S/D No.: 87-55 Name: POST #273 AMERICAN LEGION ADDITION

POST # 273 AMERICAN LEGION ADDITION

WICHITA, SEDGWICK COUNTY, KANSAS

Re: S/D No. 87-55 - Post 273, American Legion Addition

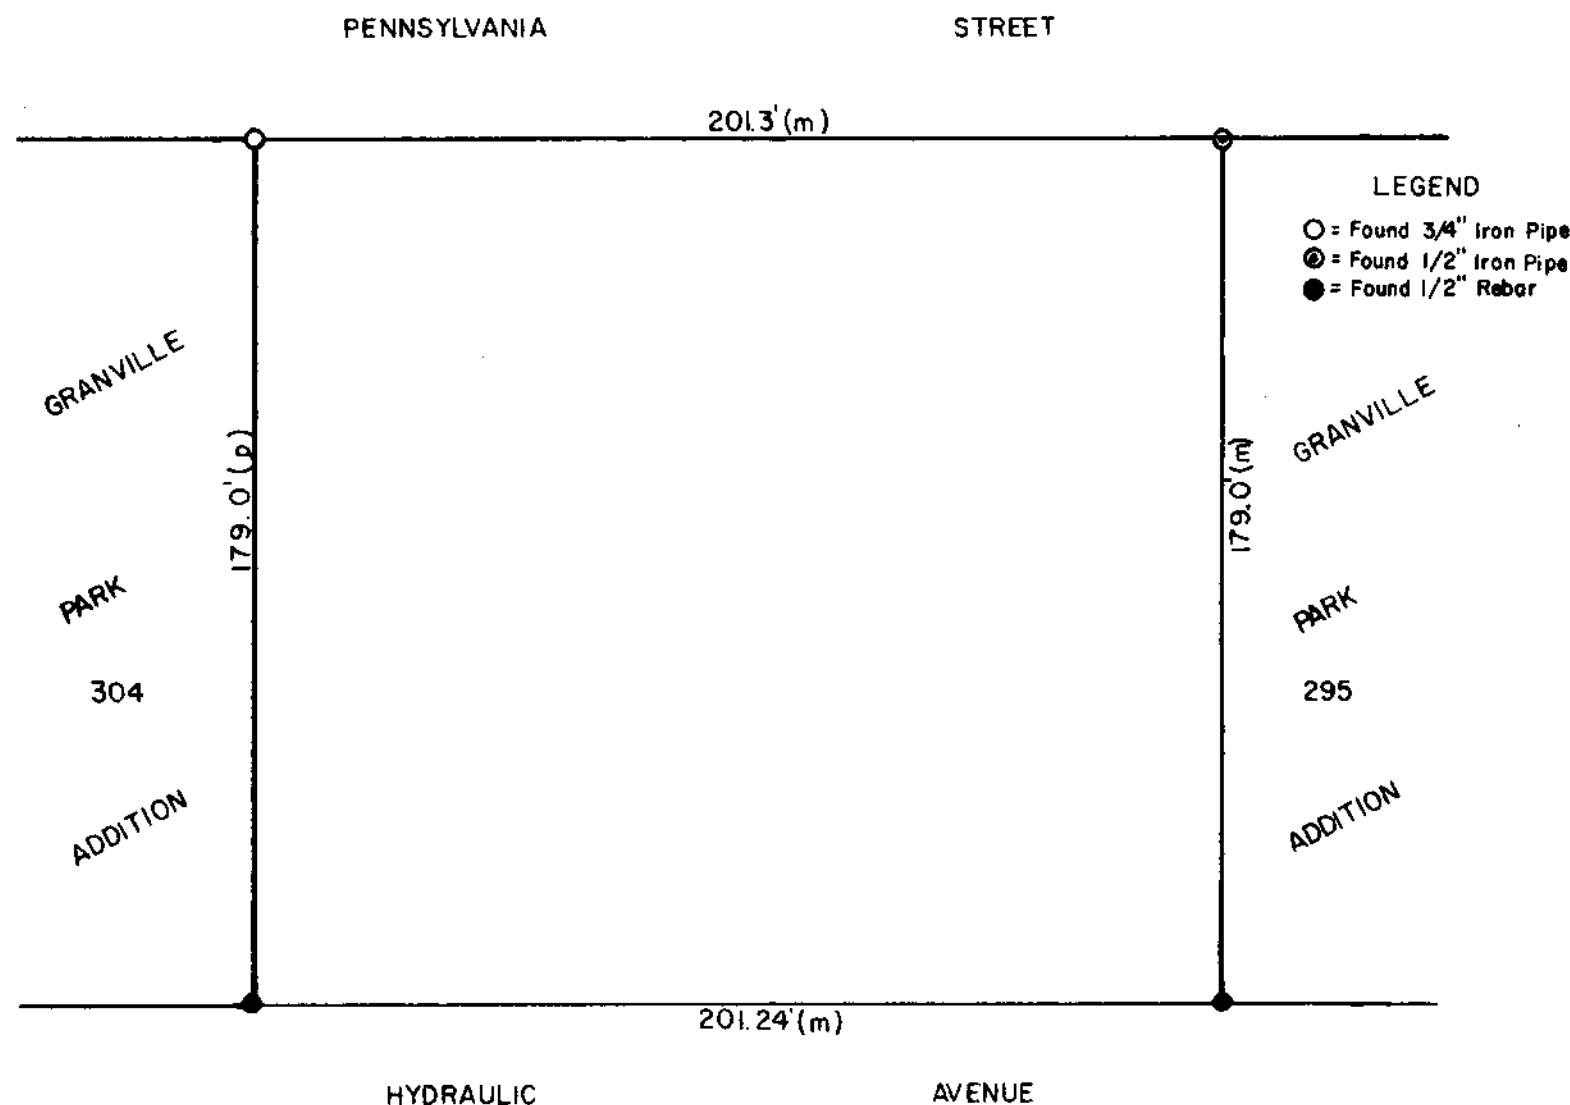
- C. The final plat tracing shall indicate the platting of "complete access control" to Pennsylvania across the west line of this lot. The platting of this access control was a requirement of the associated zone case.

- D. The platting's text shall be amended to reference the platting of access control to Pennsylvania Avenue.
- E. The final plat tracing shall indicate a 35-foot building setback from both Pennsylvania and Hydraulic.

- F. The centerlines and existing half-street rights-of-way for both Pennsylvania and Hydraulic shall be indicated on the final plat tracing.
- G. The final plat tracing shall reference a tie point to a previously platted lot corner or section corner.

- H. A lot number, lot 1, shall be indicated on the final plat tracing.
- I. The final plat tracing shall indicate angles or bearings for the perimeter of this plat.
